RE: **Major Modification to Planned Development/Phase 2 Site Plan Harbour Cay Phase II**

**Subject: Major Amendment to PD, Development, & Design Review – Harbour Cay Phase II
Technical Review Project # 21-07000005**

**RE : Harbour Cay Phase II (Harbour Isle Shoppes) – 835 Seaway Dr.
 Planned Development Minor Amendment
 TRC No. 21-07000005**

**BUILDING DEPARTMENT
TECHNICAL REVIEW COMMITTEE (TRC)
COMMENT FORM**

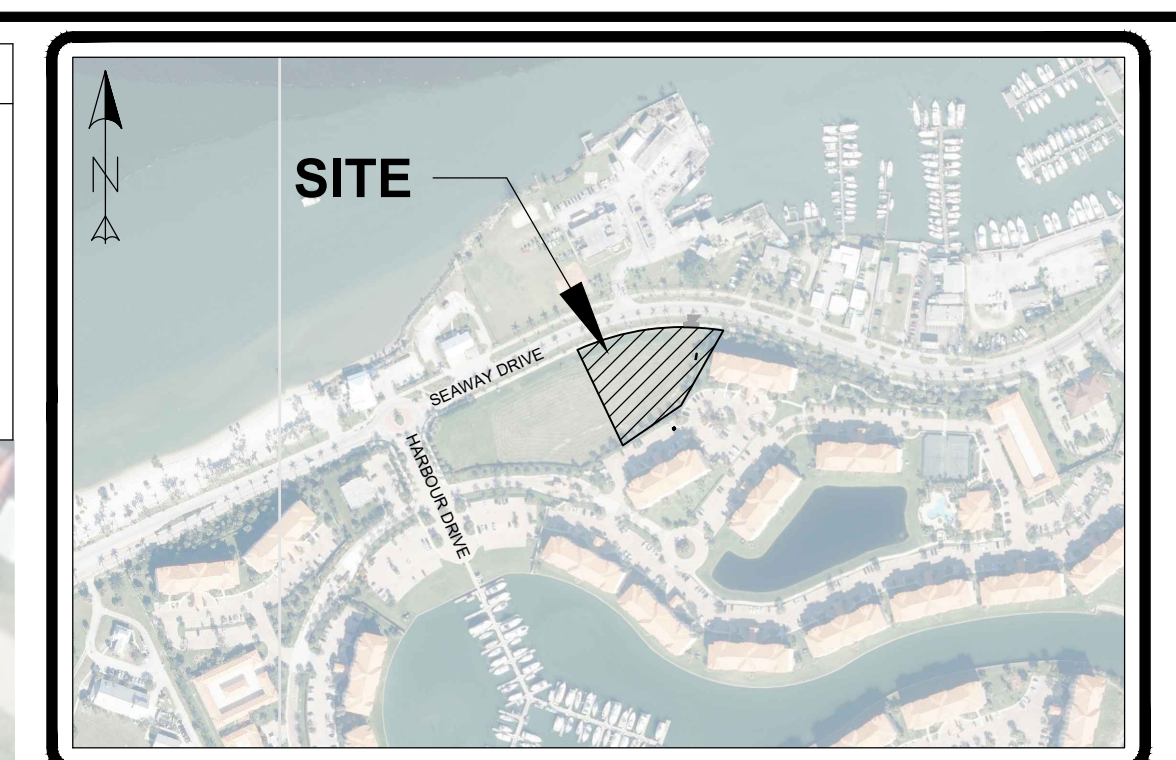
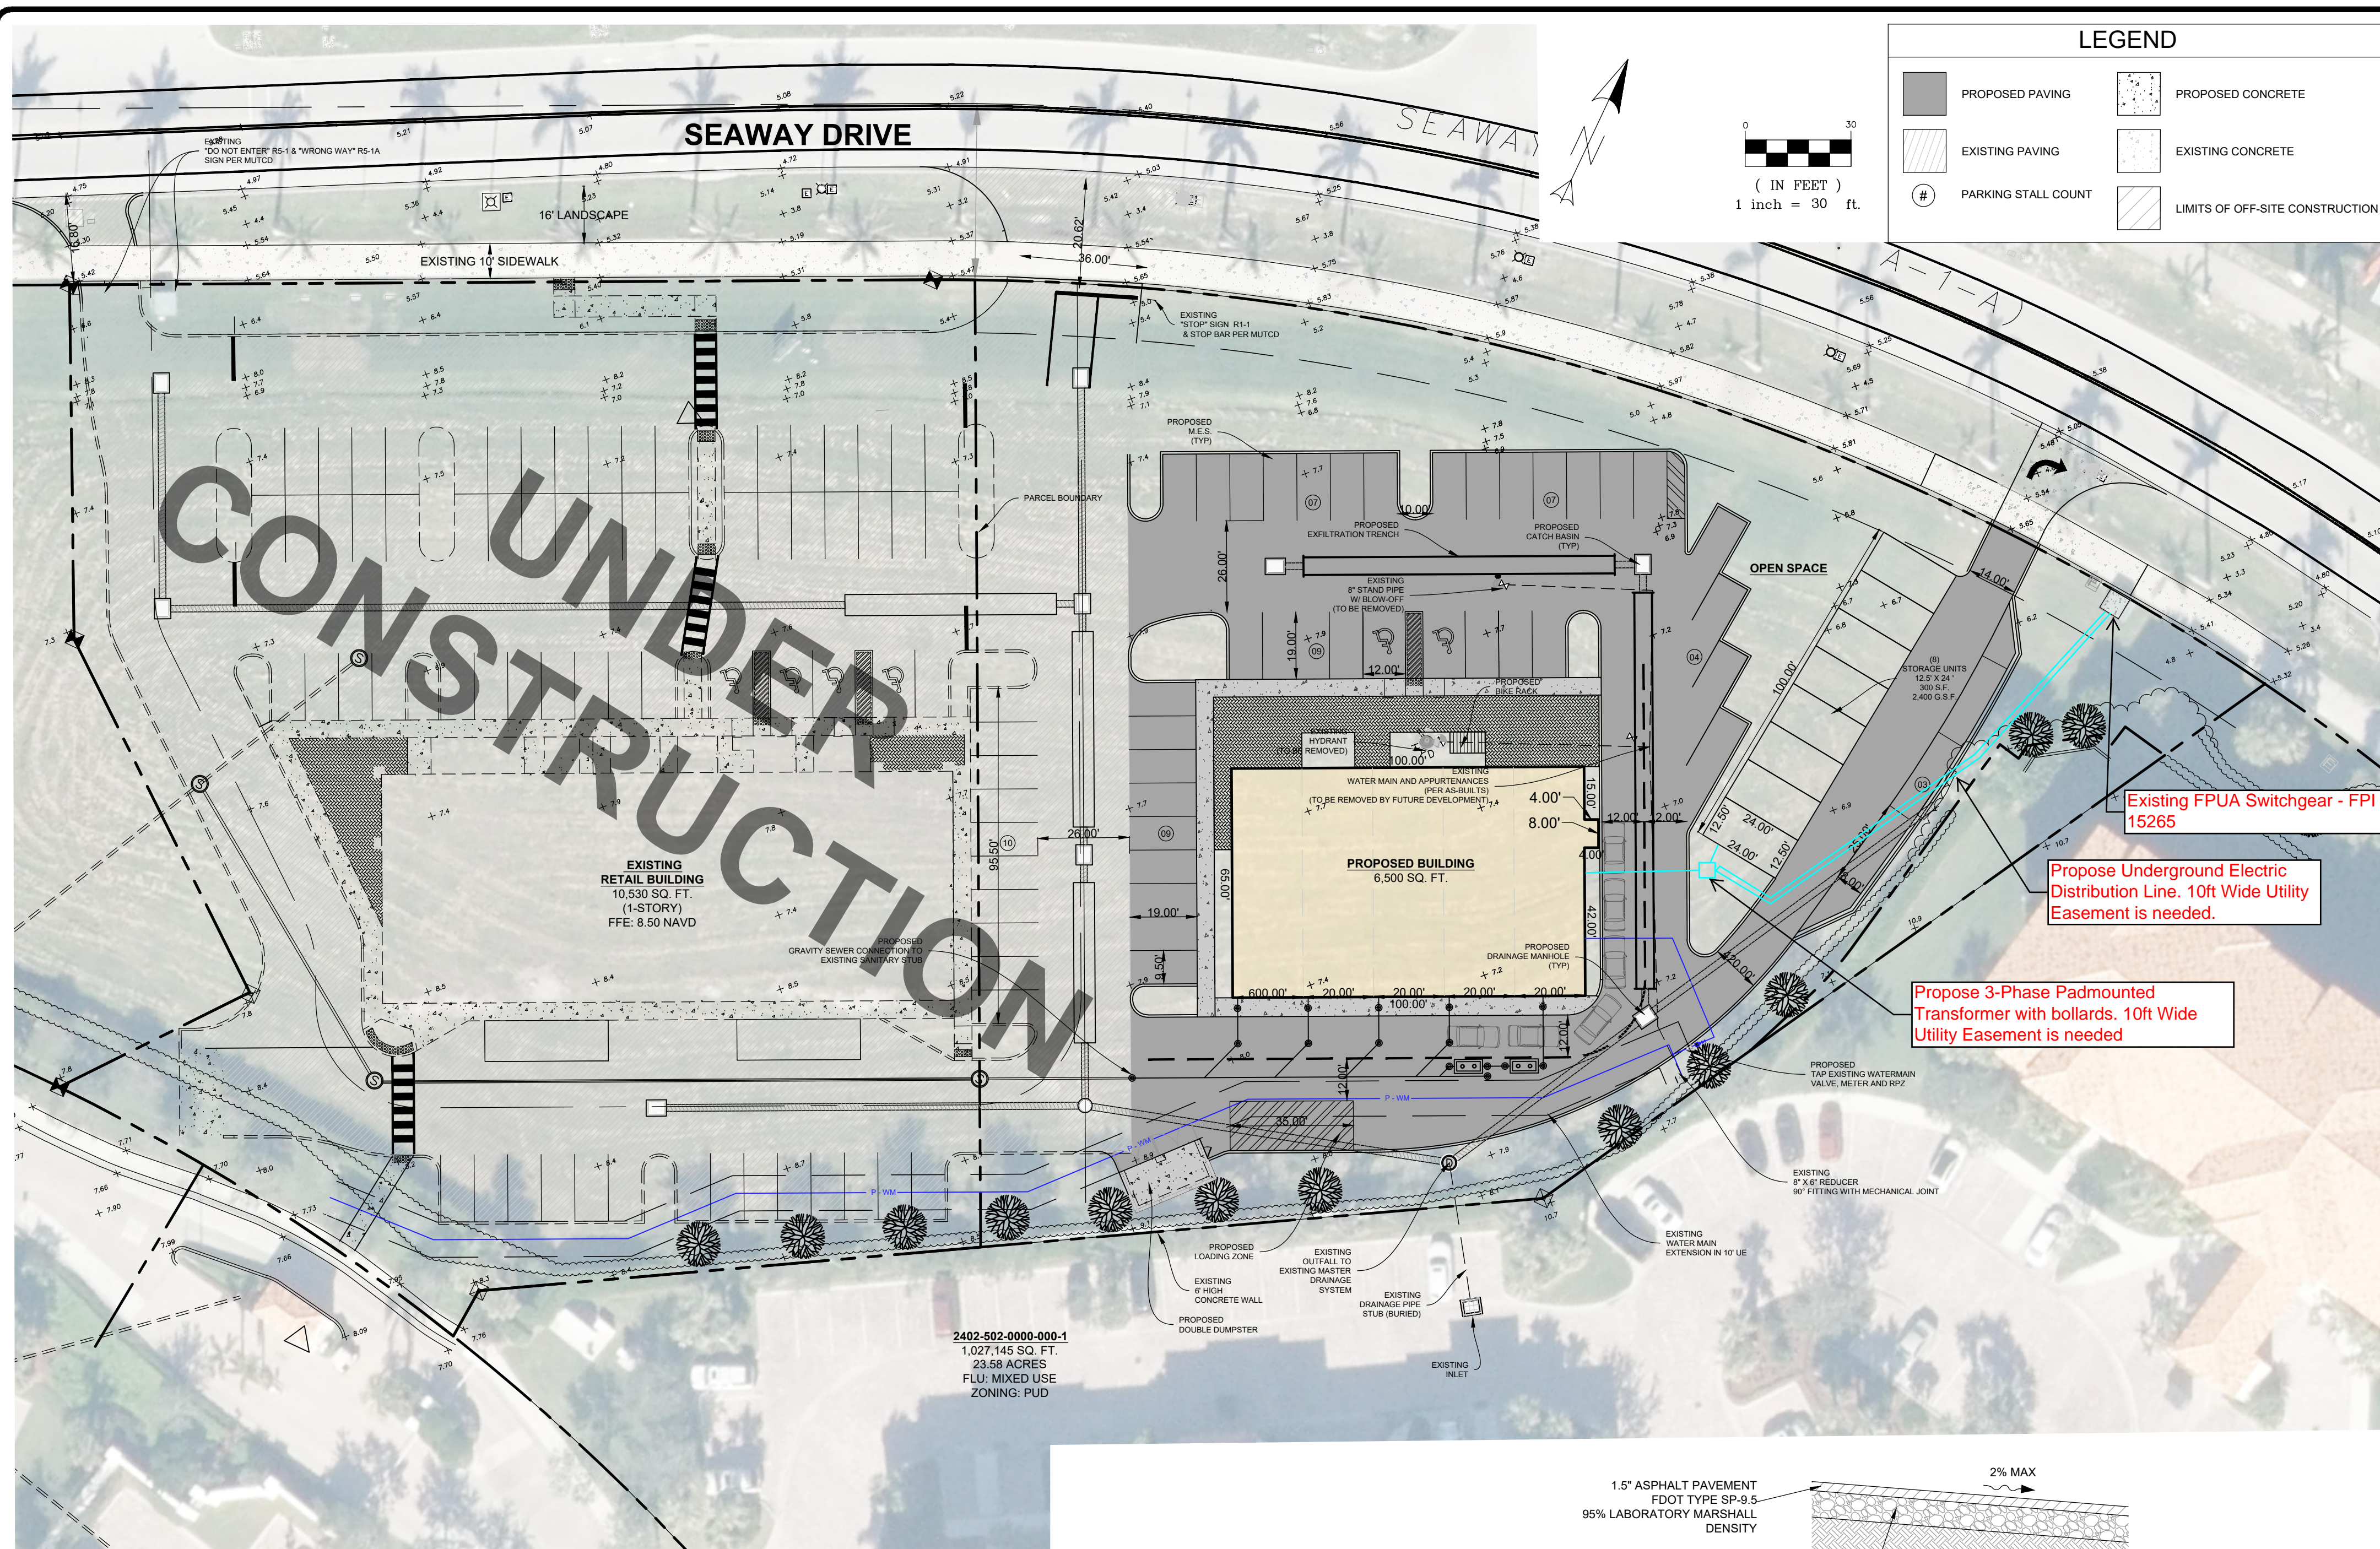
Utility easement will be required for all propose FPUA electric facilities within the site.

Please find attached the markup consultant plan, showing FPUA existing electric and our propose location for the new electric facilities within the site.
